Access Compliance Report

Public Rights-of-Way

(Pedestrian Signals)

Intersection ID: N/A	Main Street:	Cross Street: N/A	Location: N/A
ADA ID: 26385078162C	Signal Type: One Push Button-Non APS	Overall Compliance: No	Severity Score: BTN 1: N/A BTN 2: N/A No BTN: N/A
Codes/Mitigation Info/Possible Solution		Field Measurements/Component Compliance

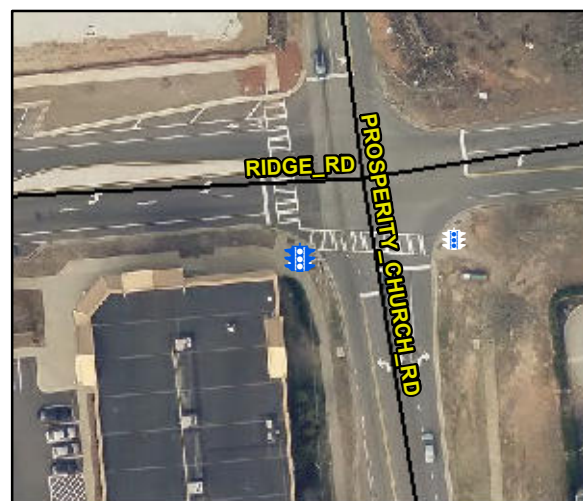
Possible Solutions: Replace Signal Push Button With APS Button on New Post. Remove & Relocate Sign.

Surveyor Notes: BUTTON IS STUCK

PROW/ADA: TMUTCD 4e.08, R404.2, R404.3, R403.4
